13554 mitchells Way

West Friendship, MD

Howard County office of Environmental Health,

From: Clay Goodier [mailto:clay.goodier@goodierbakerm.com]
Sent: Tuesday, July 22, 2014 10:26 AM
To: Oswald, Hank
Cc: Dave Harward, III
Subject: Cloverfield - Lot 9
Attachments: Cloverfield - Lot 9 - Plans - Marked Up - pdf.pdf

2451	A3.3
PROJECT NUMBER	
FIRST FLOOR PLAN	
OPTIONS	
GOODIER BAKER HOMES	
ROBINSON (3750 SQFT)	
PROJECT TITLE	
DW TAYLOR ARCHITECT	
ARCHITECT	
BID & PERMIT SET

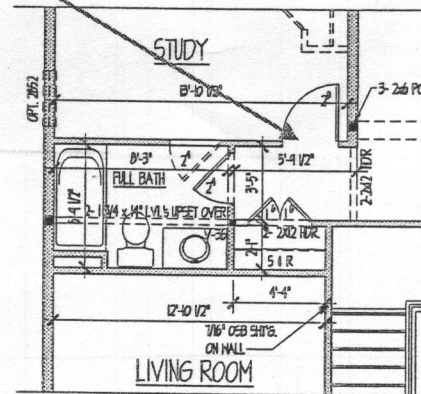
4' cased opening - No Door

I'm going to do an about-face on you. I'm going to do a 4' opening on the study without a door. That qualifies us as having 5 beds, correct? Do I need to do anything else?

Dave Harward mentioned that it wasn't apparent where I made the note on the plans. It is on Page A3.3 that shows the detail for the first floor full bath.

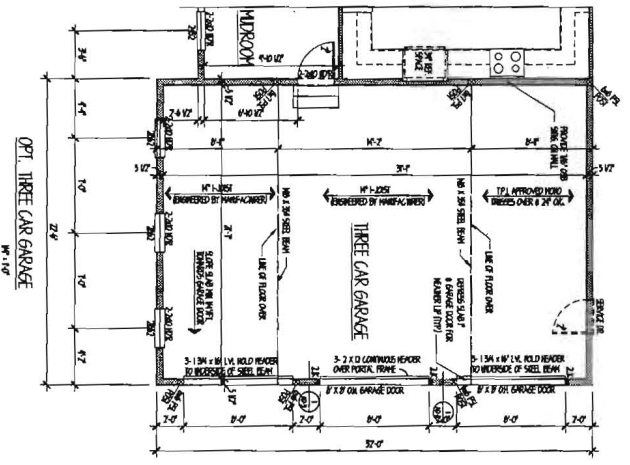
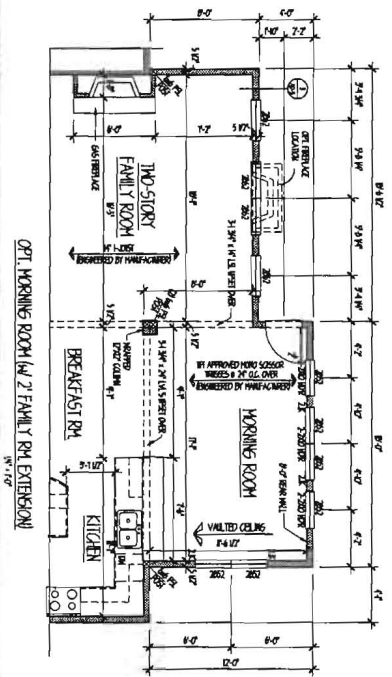
I'm going to do an about-face on you. I'm going to do a 4' opening on the study without a door. That qualifies us as having 5 beds, correct? Do I need to do anything else?

4' cascad opening - No Door
